HISTORIC LANDMARK COMMISSION
APPLICATION FOR A CERTIFICATE OF APPROPRIATENESS
APRIL 27, 2020
C14H-2010-0040
PAULSON-SING HOUSE
1705 WILLOW STREET

PROPOSAL

Demolish the existing detached garage and construct a two-story ADU at the rear of the property.

1705 Willow Street

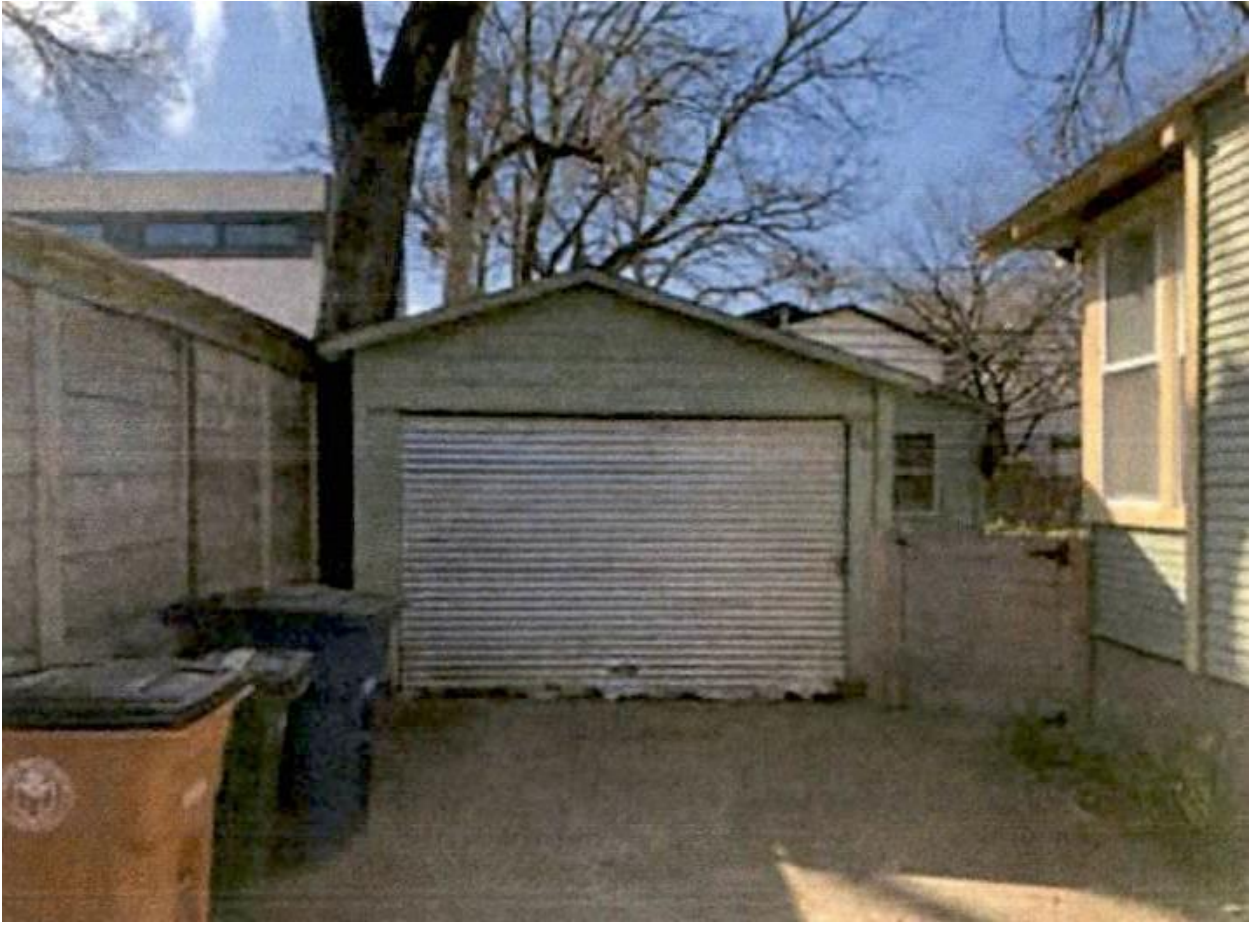
Exiting garage to be removed pursuant to this proposal.

Existing garage building to be removed pursuant to this proposal.
